47 OBERY ST.
PLYMOUTH, MA 02360

MARK	DATE	DESCRIPTION
	03/26/18	PROPOSED ALTERATIONS
	06/21/18	PROPOSED ALTERATIONS REVISED

SHEET TITLE
SECOND FLOOR
PROPOSED ALTERATIONS

A1.2

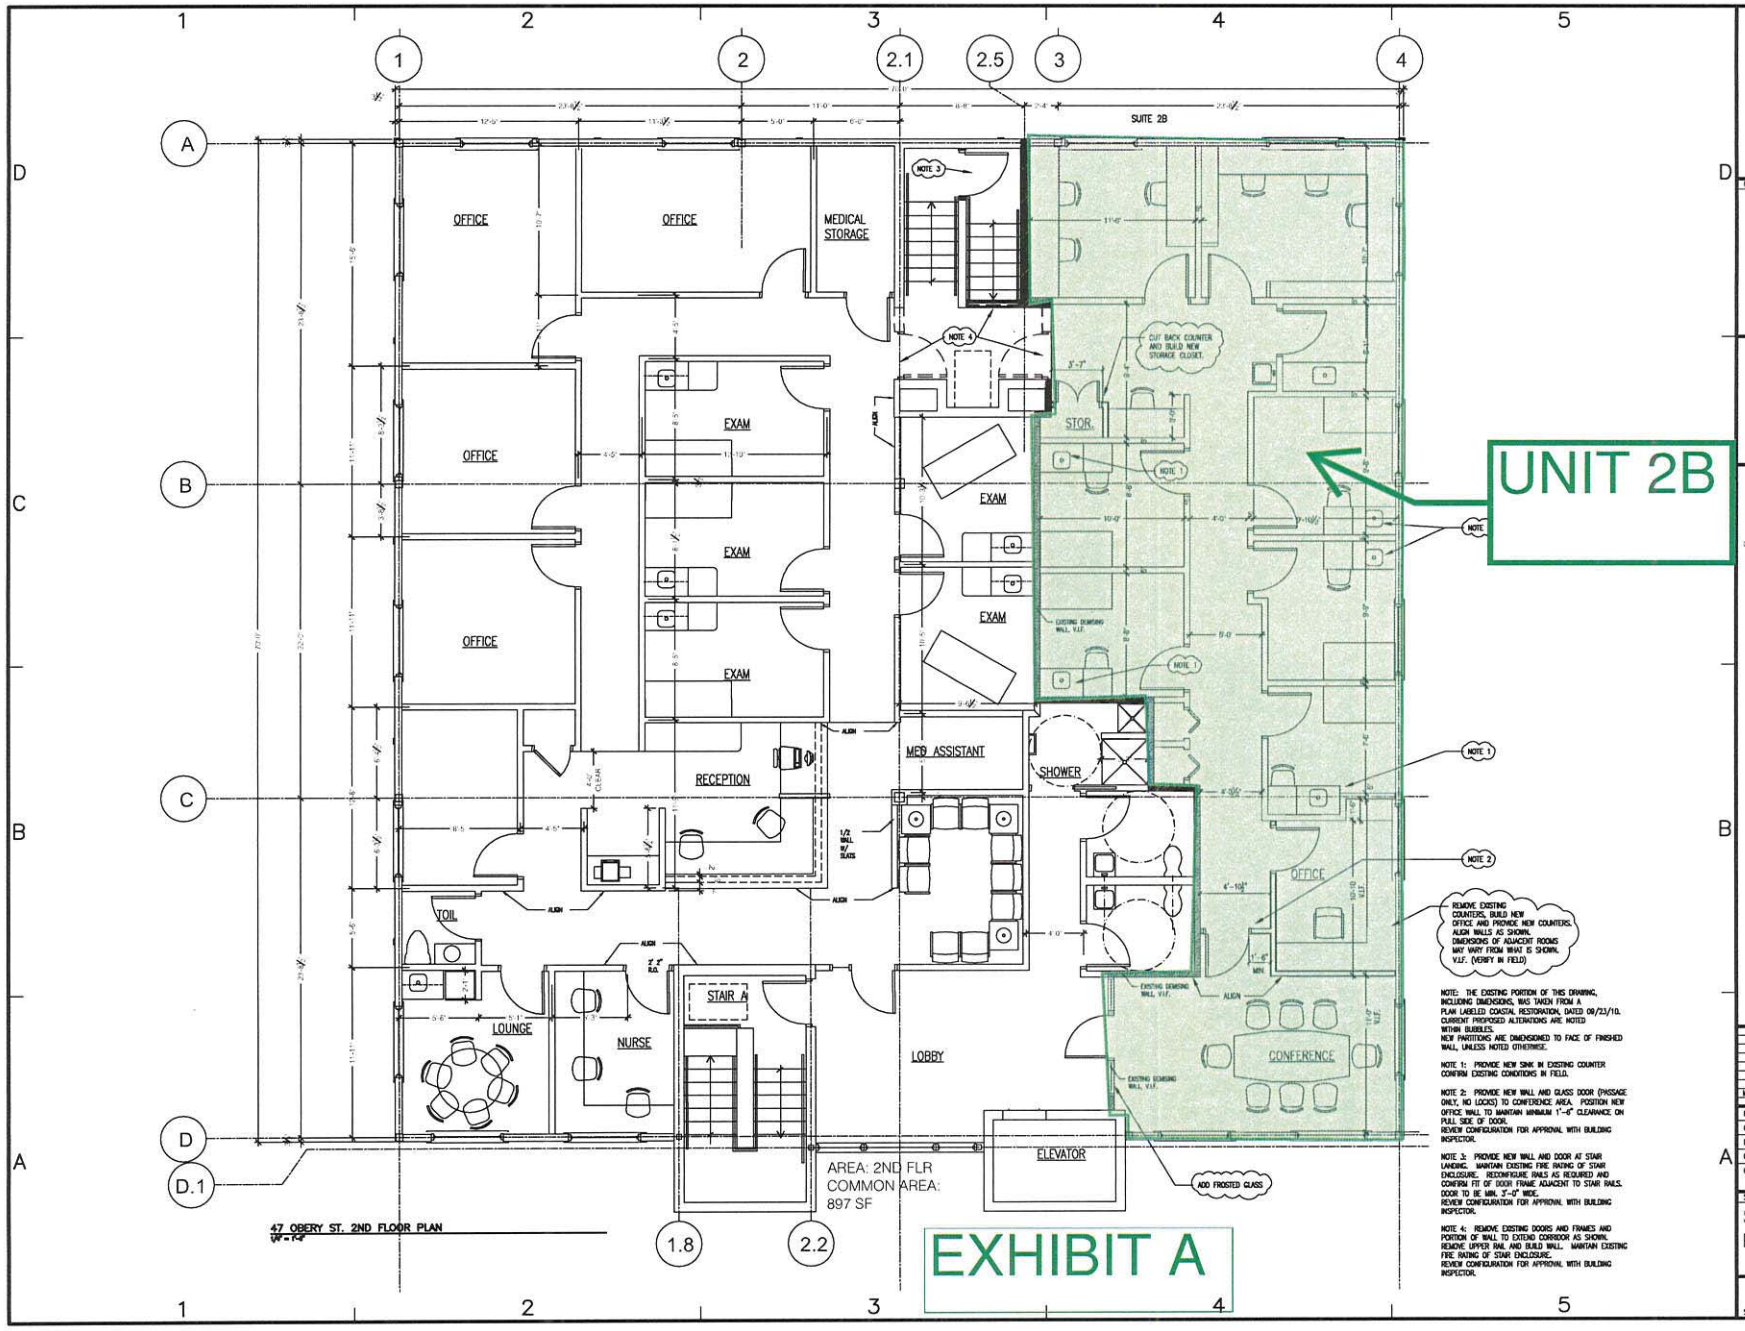
REMOVE EXISTING COUNTERS, BUILD NEW OFFICE AND PROVIDE NEW COUNTERS. ALIGN WALLS AS SHOWN. DIMENSIONS OF ADJACENT ROOMS MAY VARY FROM WHAT IS SHOWN. V.I.F. (VERIFY IN FIELD)

NOTE 1: PROVIDE NEW SINK IN EXISTING COUNTER CONFIRM EXISTING CONDITIONS IN FIELD.

NOTE 2: PROVIDE NEW WALL AND GLASS DOOR (PASSAGE ONLY, NO LOCKS) TO CONFERENCE AREA. POSITION NEW OFFICE WALL TO MAINTAIN MINIMUM 1'-6" CLEARANCE ON PULL SIDE OF DOOR.
REVIEW CONFIGURATION FOR APPROVAL WITH BUILDING INSPECTOR.

NOTE 3: PROVIDE NEW WALL AND DOOR AT STAIR LANDING. MAINTAIN EXISTING FIRE RATING OF STAIR ENCLOSURE. RECONFIGURE RAILS AS REQUIRED AND CONFIRM FIT OF DOOR FRAME ADJACENT TO STAIR RAILS. DOOR TO BE MIN. 3'-0" WIDE.
REVIEW CONFIGURATION FOR APPROVAL WITH BUILDING INSPECTOR.

NOTE 4: REMOVE EXISTING DOORS AND FRAMES AND PORTION OF WALL TO EXTEND CORRIDOR AS SHOWN. REMOVE UPPER RAIL AND BUILD WALL. MAINTAIN EXISTING FIRE RATING OF STAIR ENCLOSURE.
REVIEW CONFIGURATION FOR APPROVAL WITH BUILDING INSPECTOR.
